THE BABCOCK & WILCOX COMPANY  
POWER GENERATION GROUP

To	C. C. ENGLAND	
From	A. B. JACKSON	805 663
Cust.	TMI-2	File No. or Ref.
Subj.	REQUIRED FLOW FOR CORE COOLING	Date 12:40 A.M. APRIL 10, 1979

Subj. ALTERNATE DECAY HEAT SYSTEM REQUIREMENTS Date TIME: 7:22 P.M. APRIL 9, 1979

Minimum Core Flow Required  
for Long Term Cooling

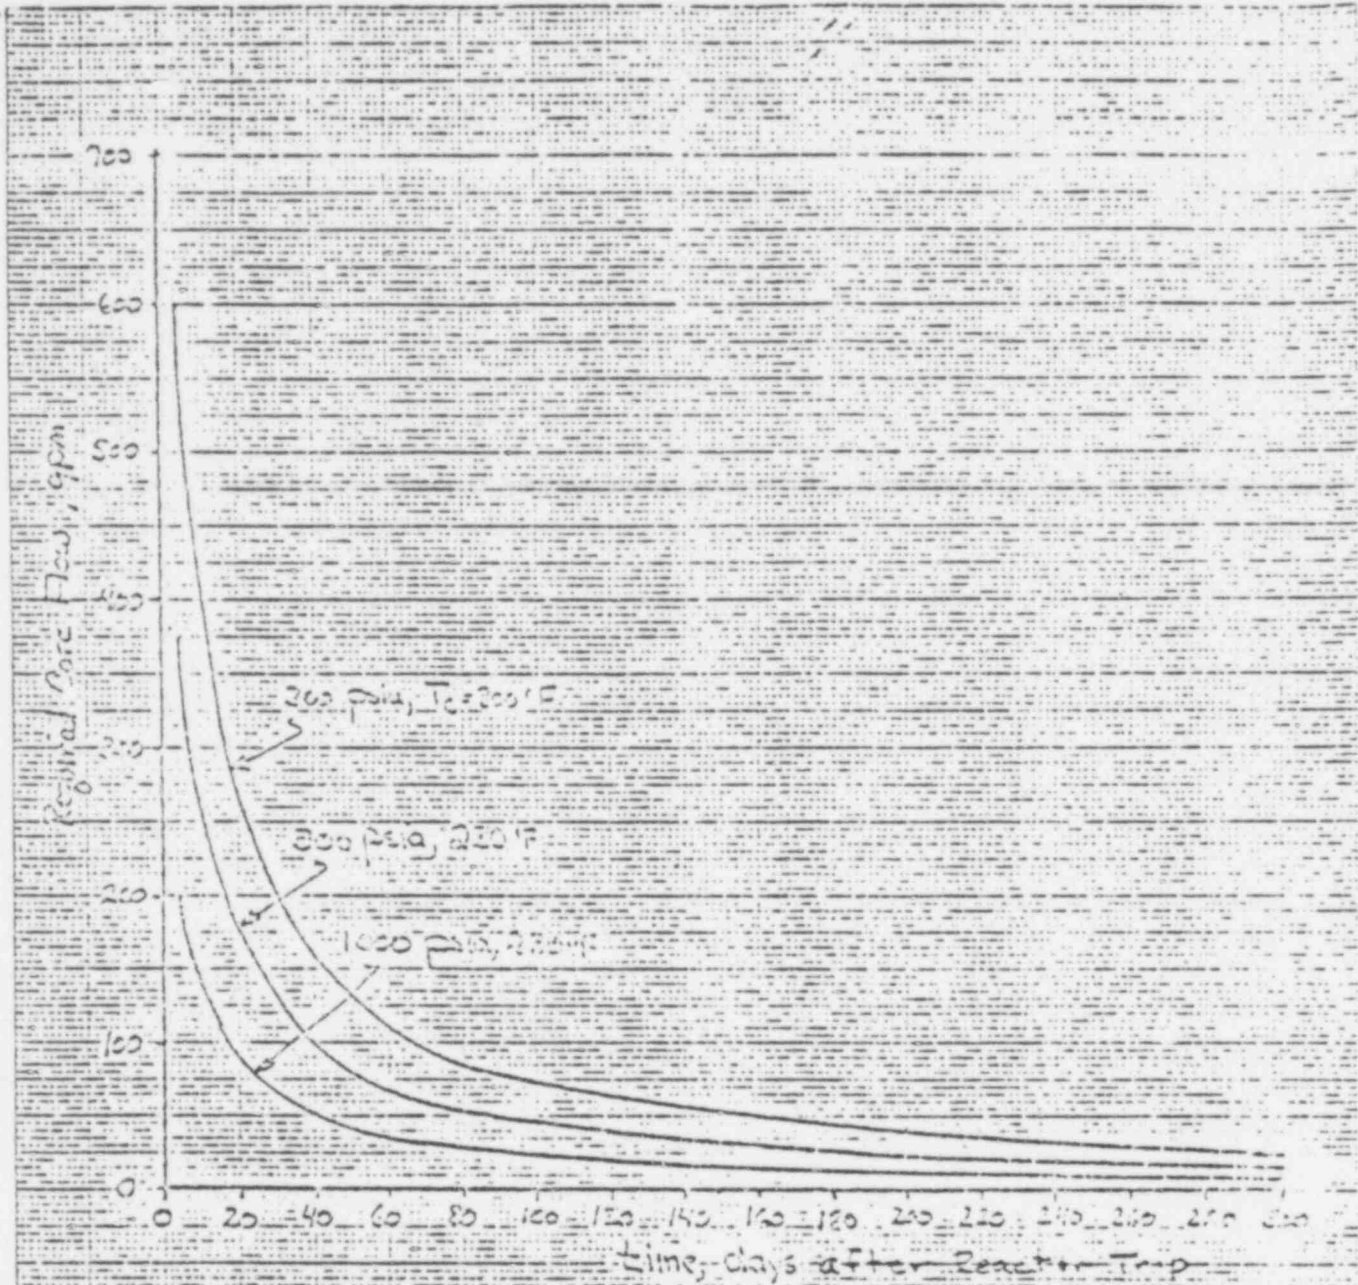
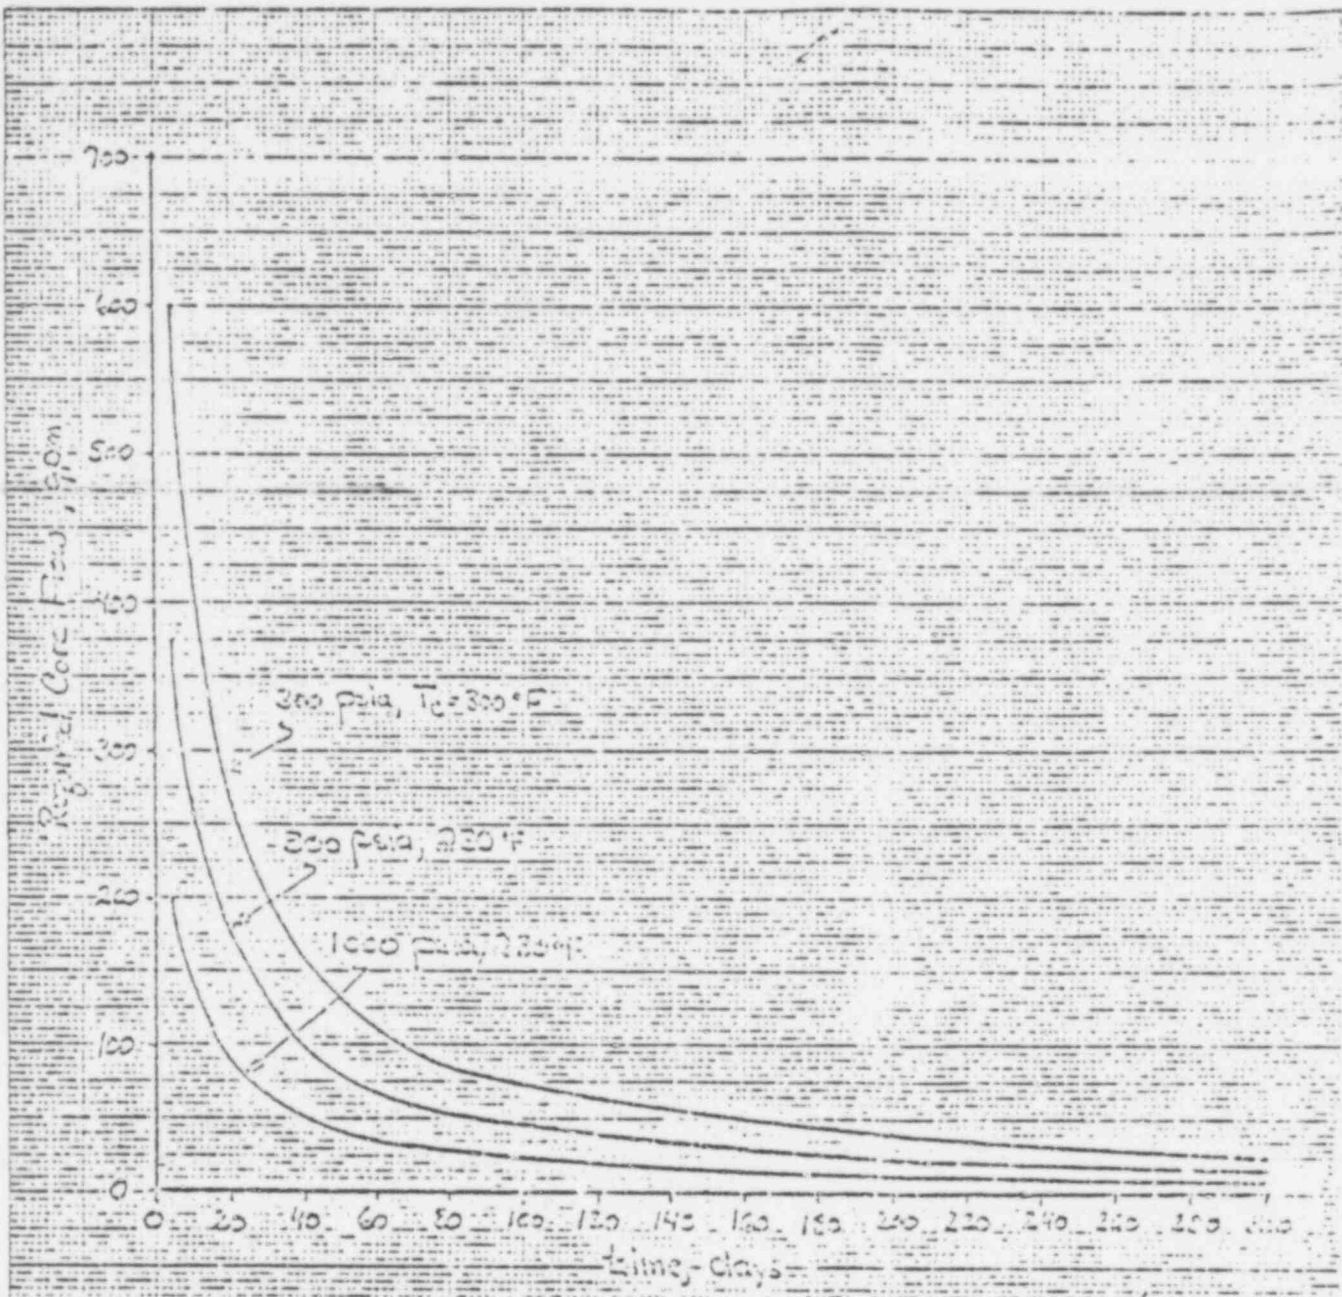
AS REQUESTED IN REFERENCE (1), THE UNCERTAINTIES INCLUDED IN THE CORE FLOW REQUIREMENTS BY T-X HAVE BEEN RE-EVALUATED BASED ON UNCERTAINTIES PROVIDED BY CENTRAL ANALYSIS. UNCERTAINTY DUE TO CORE BYPASS HAS BEEN REMOVED AND THE CORE FLOW REQUIREMENTS FROM REFERENCES (2) AND (3) ARE REPLOTTED ON FIGURES 1 AND 2. THE CONTROL ANALYSIS UNCERTAINTY OF 5.8 TIMES THE CORE FLOW REQUIRED MUST BE APPLIED TO THESE CURVES.

Decay Heat System Flow Required = 5.8 Times Core Flow
